Consent Agenda Item (Action Item): Consider/Approve Change Order NO. 20-4 for the Betsy Layne High School Renovation and Addition to JMK Electric (BG# 16-143).

Change Order Number 20-4

PROPOSAL REQUEST NUMBER: 017- Revised

BETSY LANE PR SEPTEMBER 12, 2017 - DOOR HARDWARE SPECIFICATION SECTION 087100

E5.3 **SECOND LYOOR - SYSTEMS** BETSY LAYNE HIGH SCHOOL PHASE I ADDITION 14 KEY PLAN

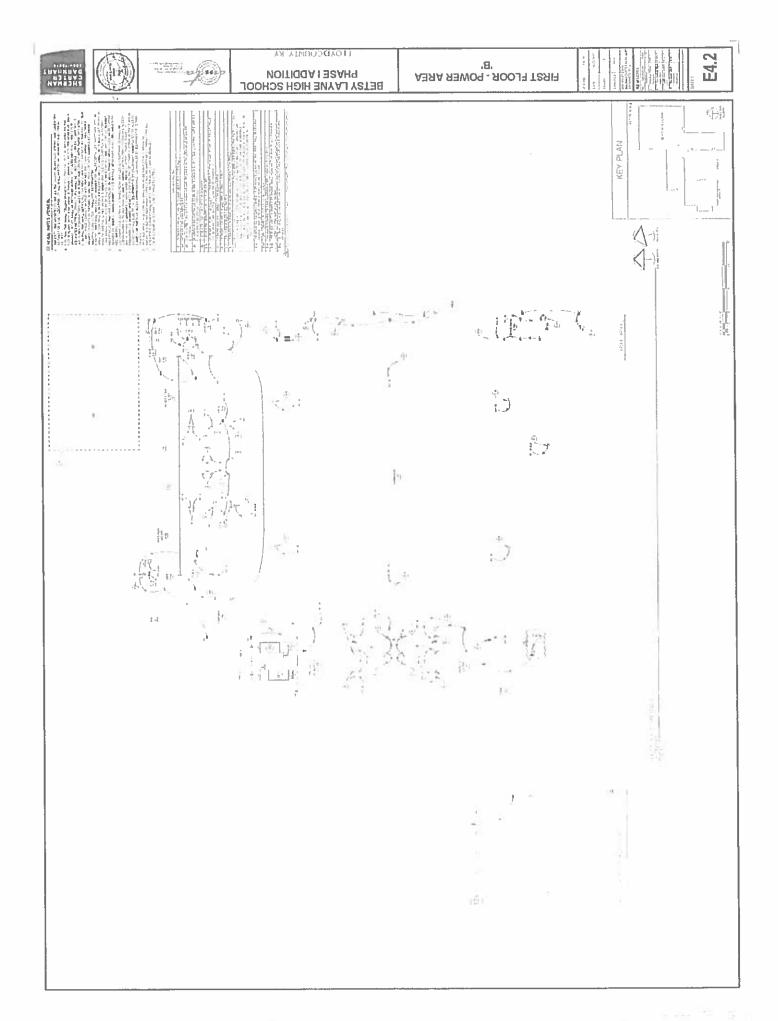
Audio only intercom stations. This should now account for all required changes.

- 1. Provide credit for the following:
 - a. Delete card readers and associated conduit and wiring at the following doors: 104B, 112A, 117, 119, 119A, 203, 204B.
 - b. Delete video intercom remote station at door E100B and video master station located in reception.
 - c. Delete magnetic door holds at the following doors: 100A, 101A, 104A, 104B.
- 2. Provide price for the following:
 - a. Provide audio intercom master station at reception desk and audio intercom remote station at door 101A as shown on attached drawing.
 - b. Relocate remote release from door E100B to 101A.
 - c. Programming indicated in note \$48.
 - d. Power at doors indicated for door hardware power as required.
